PLANNING ASSESSMENT REPORT – SYDNEY CENTRAL PLANNING PANEL

2017SCL061 – 178, 194, 204 Parramatta Road, Croydon

Report Author:	James Arnold – Consultant Senior Town Planner
Date of Report:	27 March 2018
Property Address:	178, 194, 204 Parramatta Road, Croydon
Proposal:	Development Application No. 089/2017 – Construction of a four storey car showroom with basement workshop.
Applicant:	Urbis Pty Ltd
Zone:	B6 – Enterprise Corridor

Figure 5. Marked photomontage demonstrating the cantilevered roof form which visually caps the building below the height limit (Source: Turner / Marked: James Arnold)

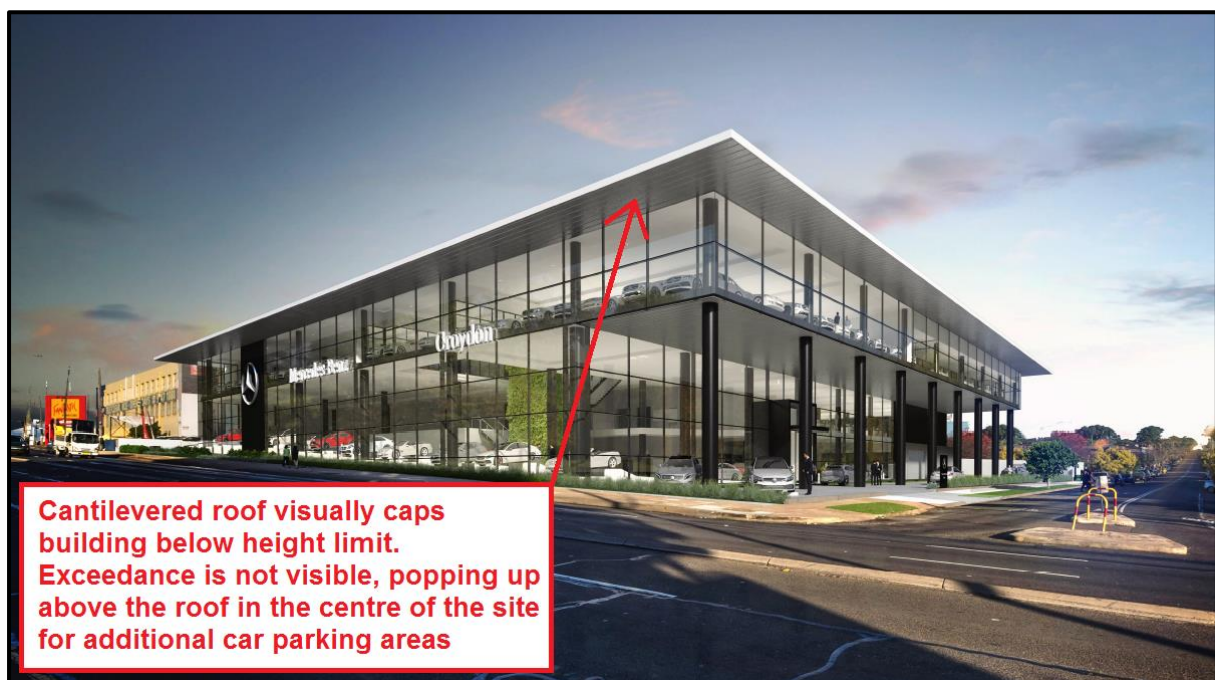
- The building height at the most prominent and sensitive parts of the site to the frontages and the southern interface with the adjoining residential zone, are well below the permitted 15m height limit. This lower height is capped off by a flat roof which cantilevers into the setbacks resulting in a perceived building height below 15m (**Figure 5**).

Figure 6. Marked section CC demonstrating the height non-compliance is the result of the rooftop car parking (Source: Turner / Marked: James Arnold)

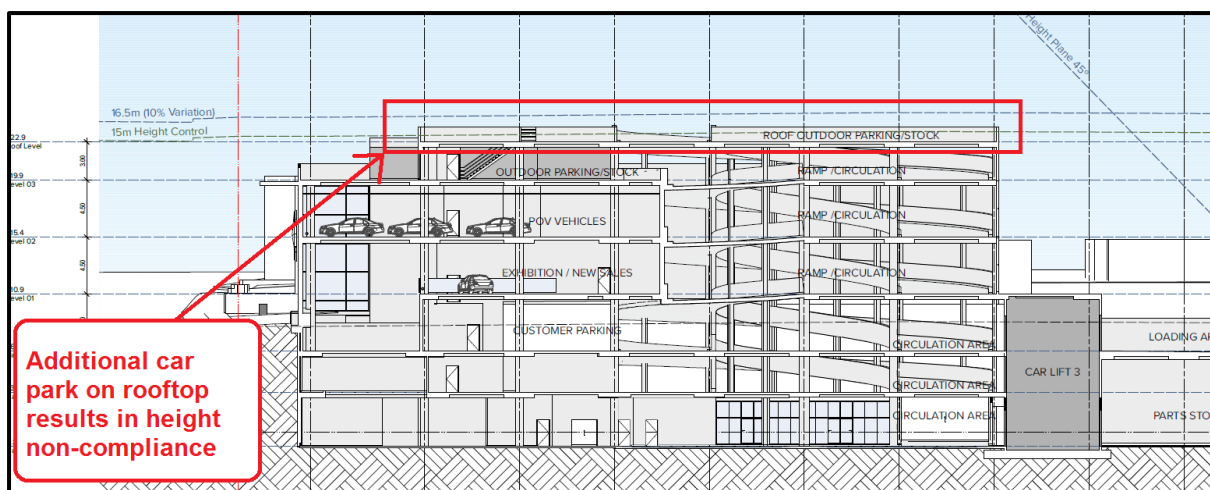
- The portion of the building exceeding the height limit is for the rooftop car parking area and balustrades and lift overruns associated with this area (**Figure 6 & 7**). The rooftop car parking area is necessary to achieve a level of parking nearing compliance with the Burwood Development Control Plan providing 50 car spaces. Without the rooftop parking, the height non-compliance could be rectified, however the shortfall in car parking would be significantly greater. Given the lack of impacts associated with the additional height, the additional car parking on site is considered the preferred planning outcome.

Figure 8. Marked ground floor plan indicating proposed car parking spaces within the Lucas Road setback (Source: Turner / Marked: James Arnold)

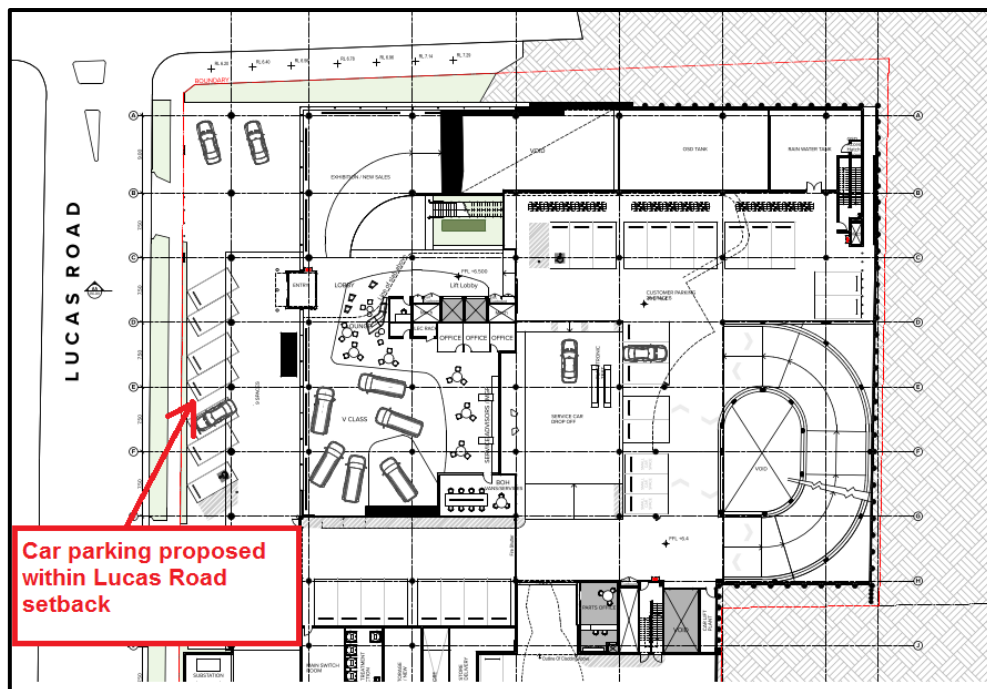
The proposal includes nine car parking spaces within the setback area to Lucas Road which does not comply with the above control (**Figure 8**). This non-compliance is considered acceptable for the following reasons:

- The building façade is clear glazed curtain walling which creates a visually permeable building. This will ensure that significant visual interest is drawn to the building itself and not the few car spaces in front.

- A landscaping strip is proposed in front of the car spaces which will soften and screen the area from the street.
- The car parking is considered appropriate for the use of the site as it will provide a quickly accessible car space for short stay customers. This will ensure that not all customers will be required to enter the building car park and unnecessarily add to vehicular movements around the site.
